AGC/WSDOT Structures Team

January 22, 2021

Agenda
AGC/WSDOT Structures Team
Microsoft Teams Meeting
January 22, 2021 -- 9:00 AM – 12:00 PM

The south end of the bridge must pass over BNSF railroad and under PSE power. Here is a plan view for the south abutment and railroad area.

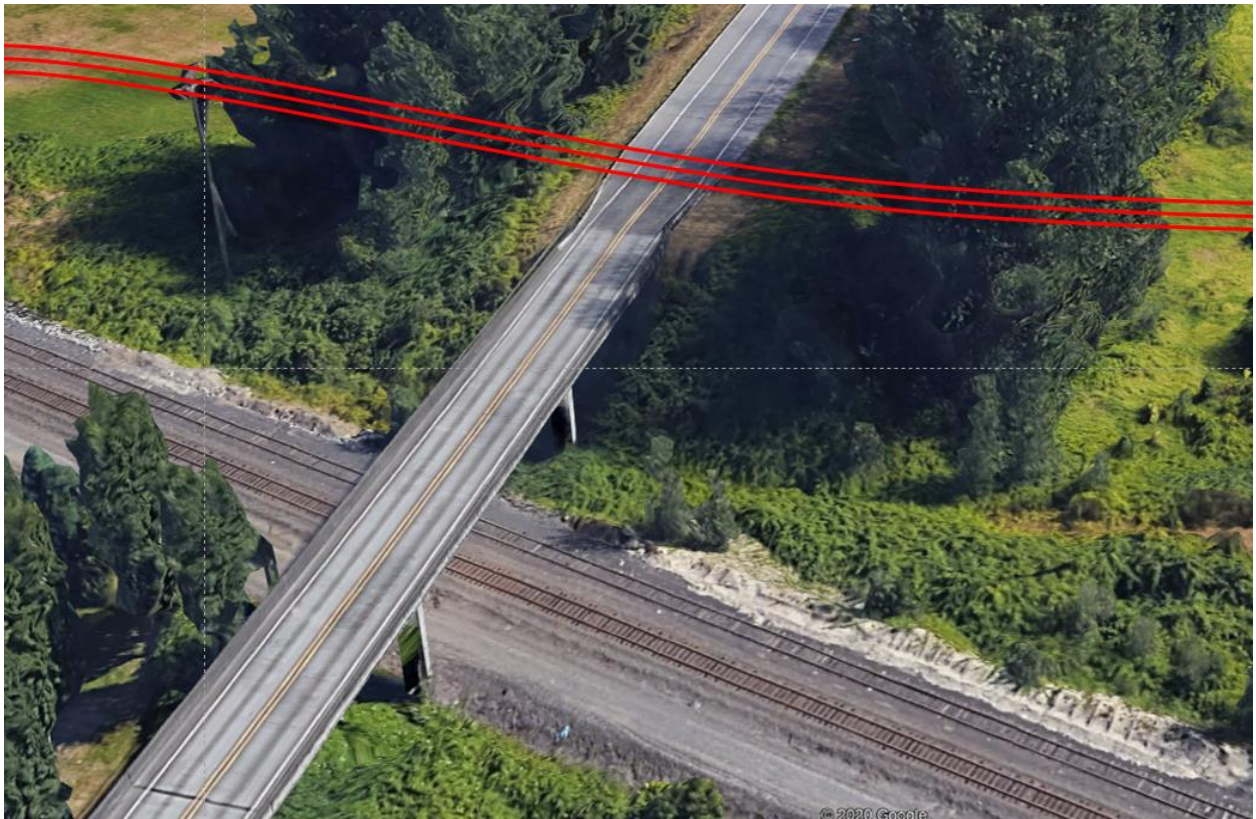
Amy Leland wanted to discuss the placing of the girders under the power lines and over the R/R. With the power lines there, it was stated there is no way to do a single crane pick. You would have to use two cranes but in order to do that you need to get the girder down under the power lines. The power lines would need to be de-energized during girder setting. Use of a trolley system was discussed, but it would still likely require two cranes. Neil Hunt wanted to avoid using hydraulic jacking to lift girders if at all possible. It was asked if this part of the bridge could be cast in place thereby avoiding girder sets altogether. With the R/R and the need to keep a construction opening functional, this option was not popular with the bridge office or project office.

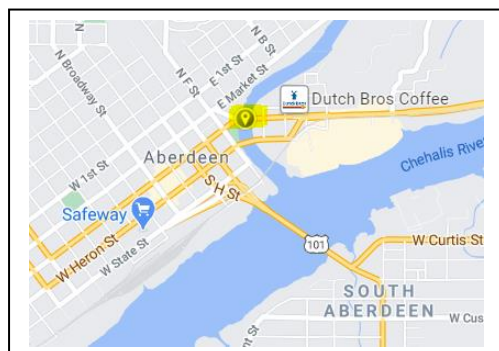
The need for scaffolding was brought up depending on what work was needed outside of the 14 day closure. If scaffolding were used, it would need to not preclude operation of the leaf.

The consensus is that 14 days might be enough time, but they really want to see the connection details to be sure.

ACTION ITEM: Patrick will work with Nick to get the connection details distributed to the team by e-mail so that they can provide a better response on the timing.

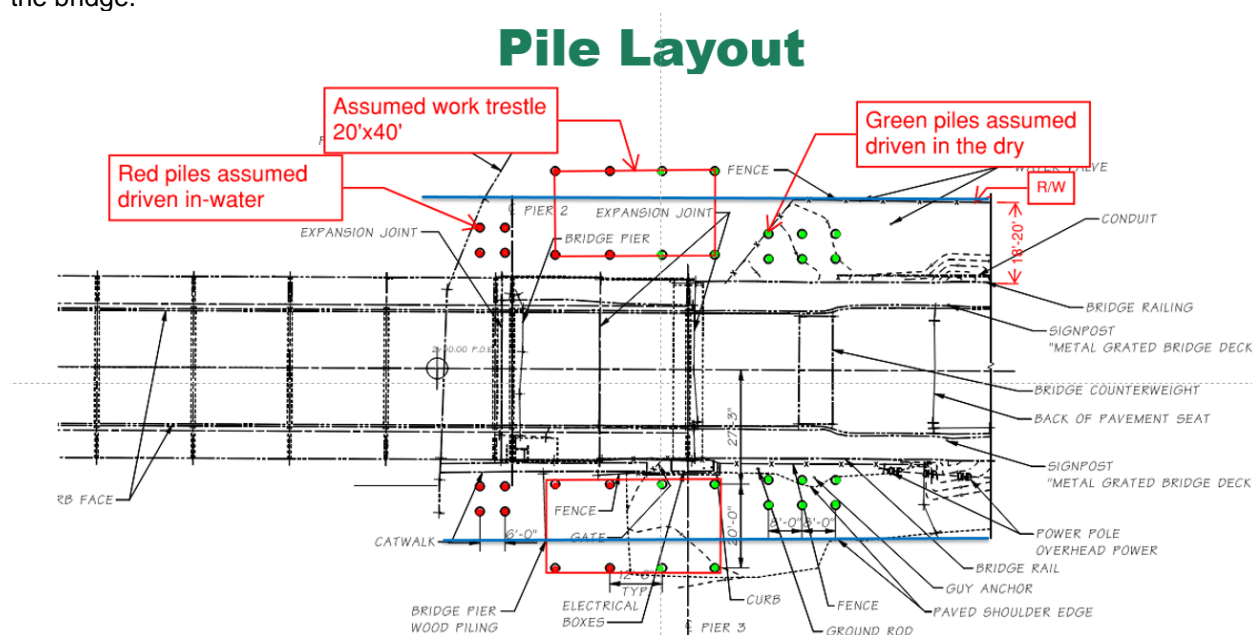
Access – R/W from edge of bridge is ~ 18 to 20'. Is this enough room for crane access?

Jacking Scheme – To take the load off the trunnions and links, Geoff thought they needed to raise the counterweight about two inches. Raising the counter weight 2 inches also causes it to rotate back about an inch. WSDOT will develop suggested details but will still require a submittal. Geoff wanted to know if the contractors had any concerns about having to prepare a jacking plan and submittal.

No concerns about having to prepare a submittal, but there were comments to make sure WSDOT provides enough room for workers and access in their concept details. There were also questions about the stability of the counterweight. Neil Hunt pointed out it looks like it was designed to be suspended. He was concerned about its stability when being supported from beneath. Geoff pointed out that the counterweight would probably need some corner/edge reinforcement to make sure there is no spalling or shearing if jacking locally.

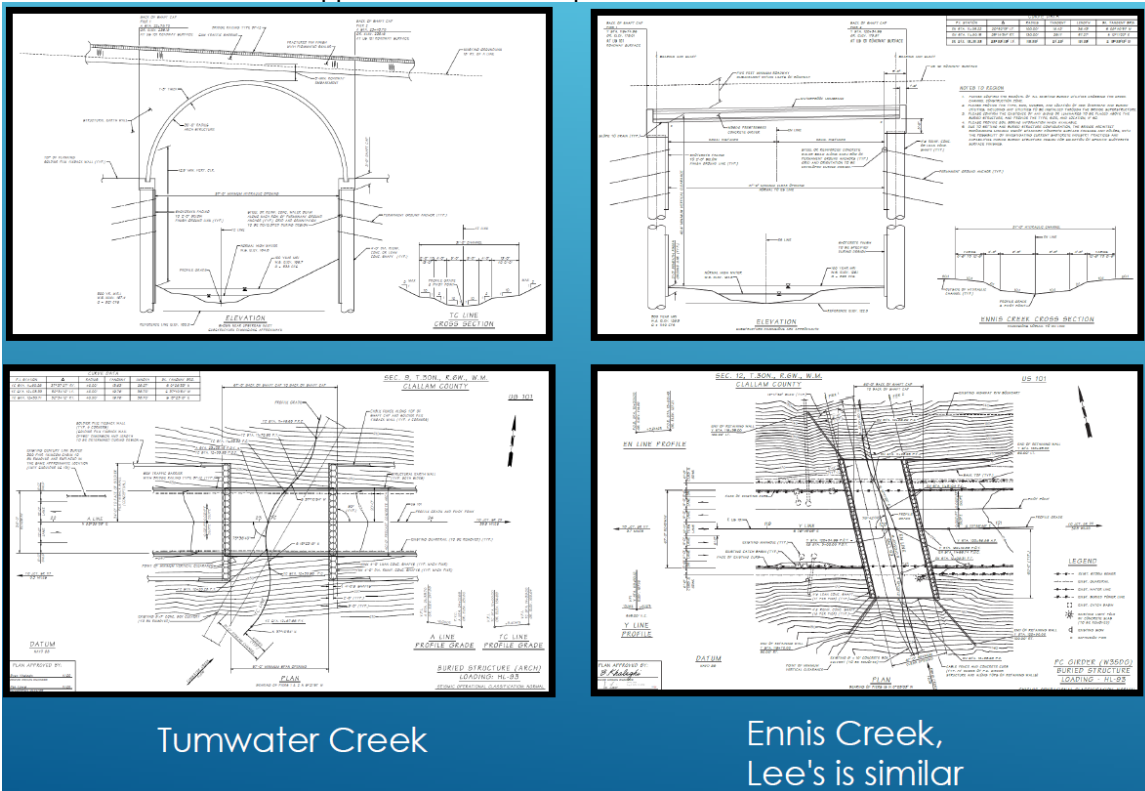
Q: Jim Cuthbertson asked if there were any concerns with production, shapes, or shipping that the team wanted to raise.

A: Stuart Moore mentioned that in the picture above the footing on the precast wall could be an issue it is too large. He suggested limiting widths to 10 feet or less for shipping. Bijan stated that the picture was just illustrative and did not represent an actual standard plan, but that they are working with industry regarding width, height, and weight of components for shipping. Jim Cuthbertson suggested that walls could be fabricated in two pieces, and a closure pour could be used to lock them together. Stuart suggested using a full height panel with reinforcing like a MSE wall as an option too. Piper Pettit mentioned that she had a project with a split box culvert that had different leg length between the top piece and the bottom piece. She

DISCUSSION TOPIC #2 - Alternative Span Types

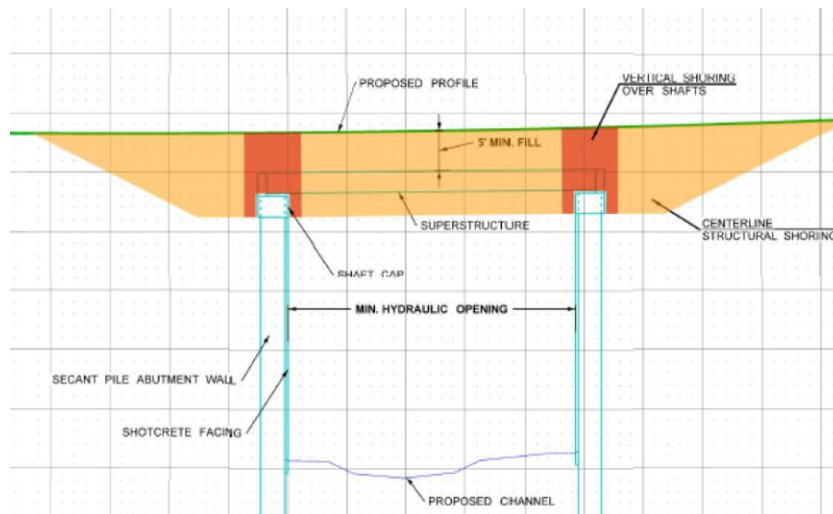
Given this 14 day time constraint, would a precast or plate arch be a preferable superstructure type to decrease number of CIP elements and lessen schedule risks?

A: Kelly Griffiths – Setting arch shapes would probably be slower and the shaft caps would be more detailed to form which would also be slower. All that you are really deleting is some of the earthwork, and that was probably the fastest earthwork.

A: Neil Hunt – Stated that these shapes may be harder to get, and Kelly pointed out that you may not be able to ship as many pieces at once or stockpile them as easily in the work zone either. Neil also pointed out that the change in shape would likely drive the shaft caps deeper which will complicate the shoring issues and increase the costs associated with shoring, excavation, and backfilling.

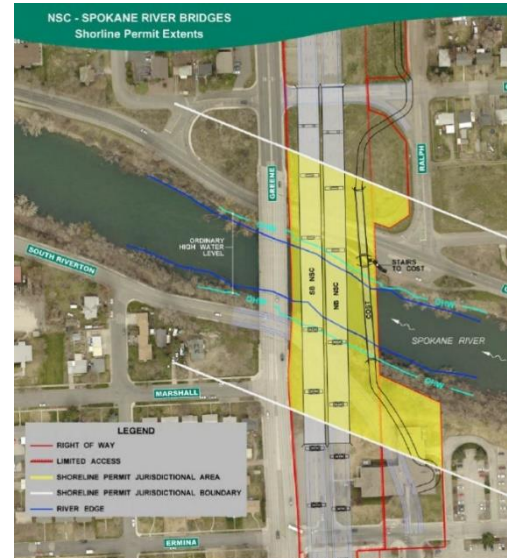
Q: How would structural shoring methods be modified at Lees Creek, where 1 ft of concrete pavement from original US 101 roadbed is located 7.5'- 8' below existing grade along centerline?

A: Kelly Griffiths suggested predrilling or excavating down and breaking up the concrete prior to shoring.
